From: Nelson, Dan
Sent: Thursday, June 01, 2017 8:39 AM
To: 'Terry Scanlan'
Subject: RE: Sabal Whitetail Permits.

From: Nelson, Dan [<mailto:Dan.Nelson@idwr.idaho.gov>]
Sent: Thursday, March 2, 2017 3:30 PM
To: Lori Graves <LGraves@spfwater.com>; Terry Scanlan <TScanlan@spfwater.com>
Subject: Sabal Whitetail Permits.

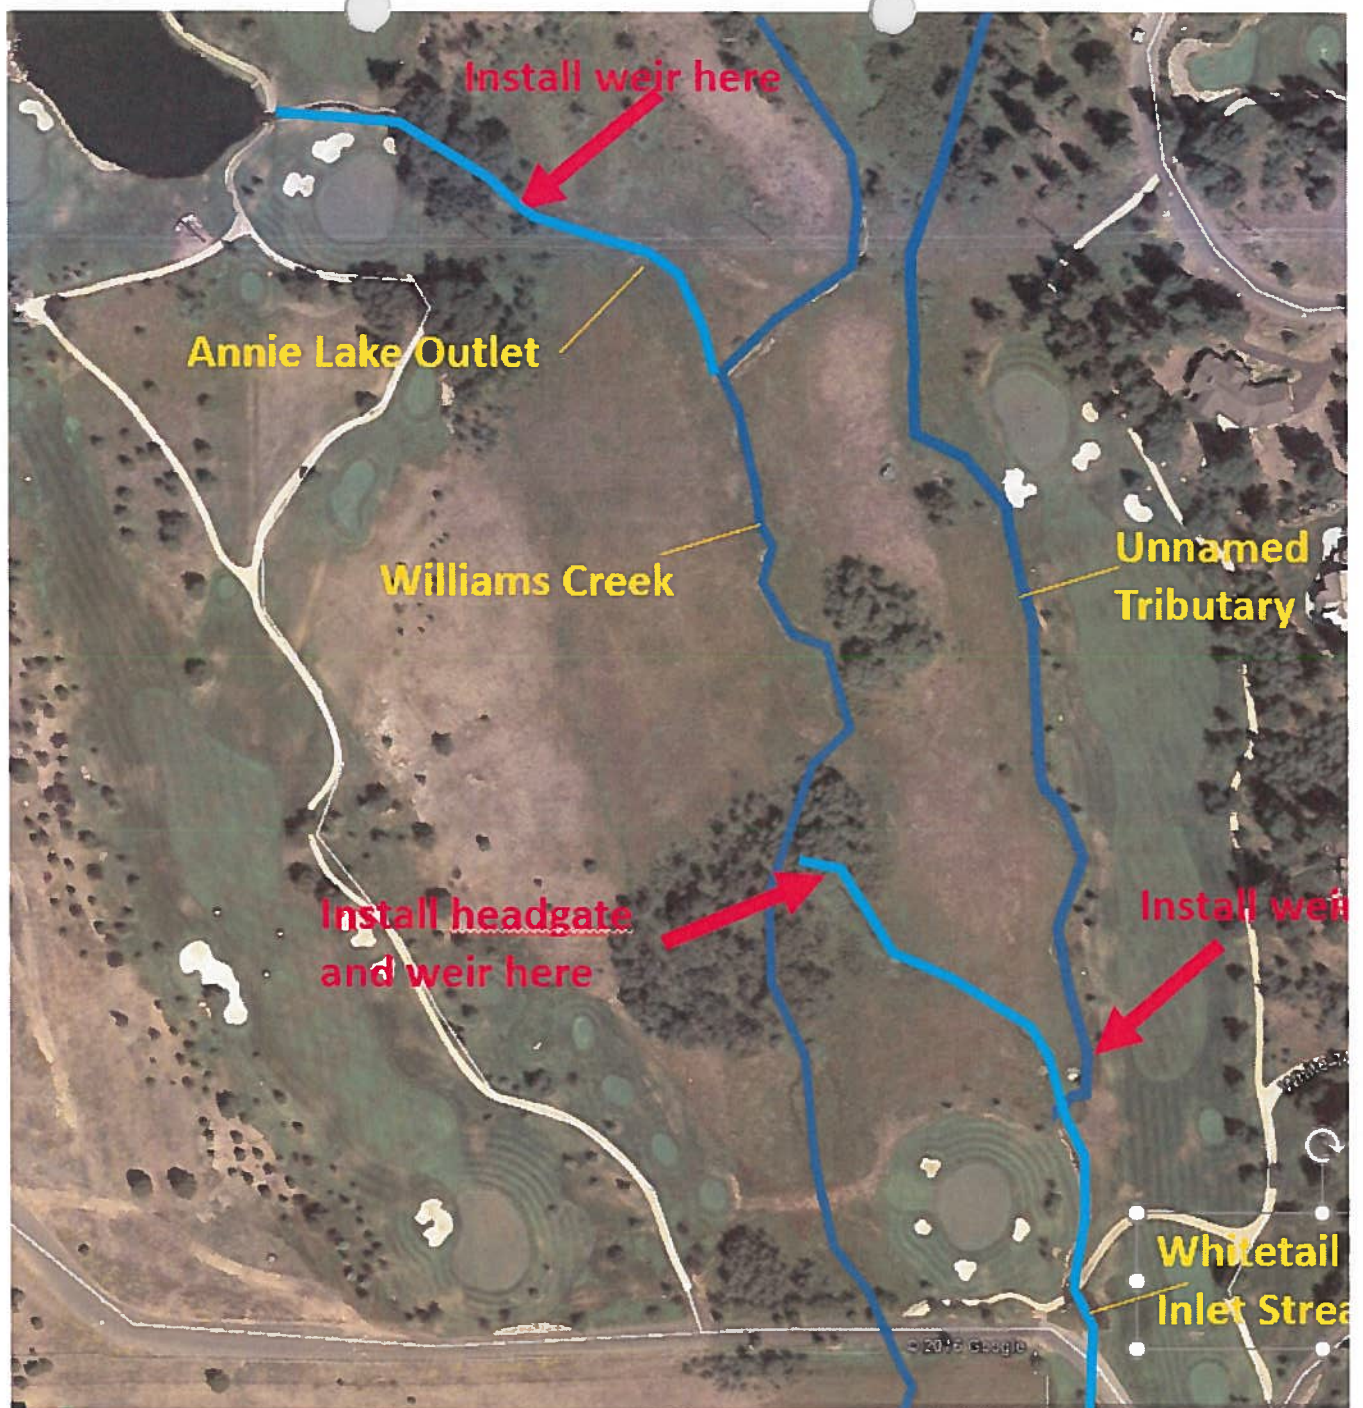
1. **65-13470 diversion volume.** The diversion volume is unknown. The 2.3 AFA volume that you proposed to cover evaporation loss seems appropriate.
2. **Douglas Lake volume.** We will prepare an application for an additional 7.3 AFA (1.3 acres x 14' depth x 0.4) of recreation storage to cover the enlarged pond. Source will be unnamed stream tributary to NF Payette River (similar to 65-7007 and 65-13453).
3. **65-2911 Diversion of Williams Creek.** I walked Williams Creek in the reach where the water from Annie Lake flows through to Whitetail Lake. My recommendation is to (1) install a weir on the Annie Lake outlet stream,

and (2) install a weir and headgate on the inlet stream to Whitetail Lake just downstream from the bifurcation from Williams Creek.

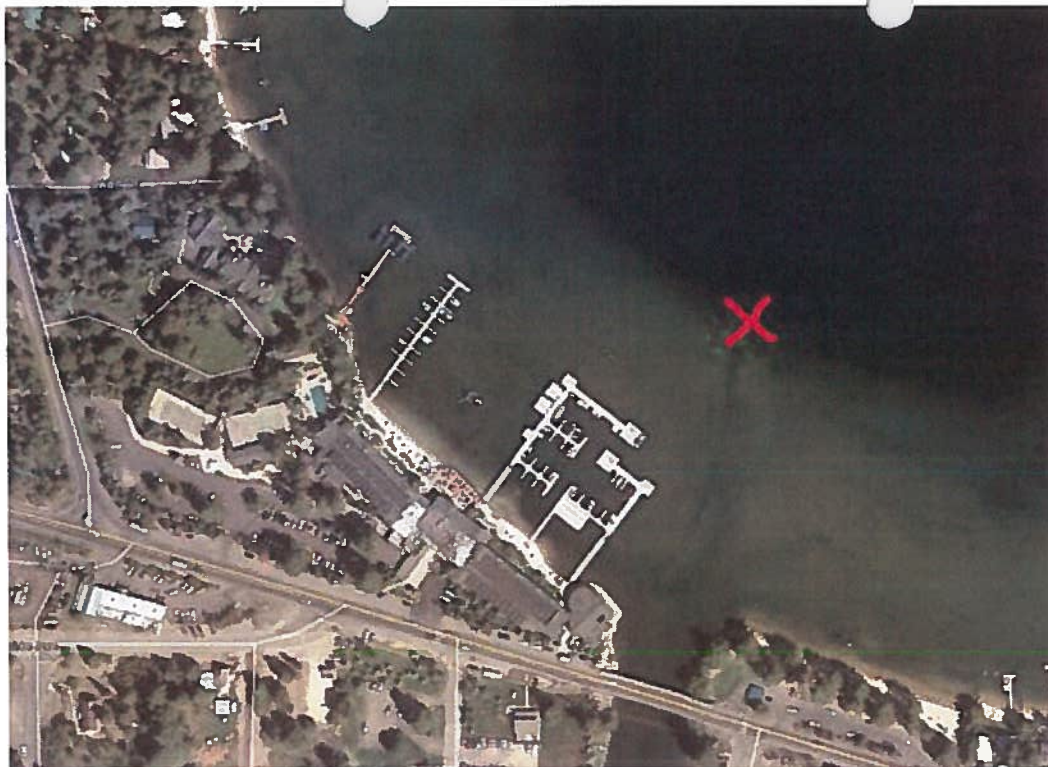
4. **65-13640 point of diversion location.** The diversion consists of a pipe out into Lake Payette that feeds a pump at the location shown on the field exam. We can show either (1) the end of the pipe (see image below), (2) the pump, or (3) the water district location. Your choice, but I think the pump station site makes the most sense.
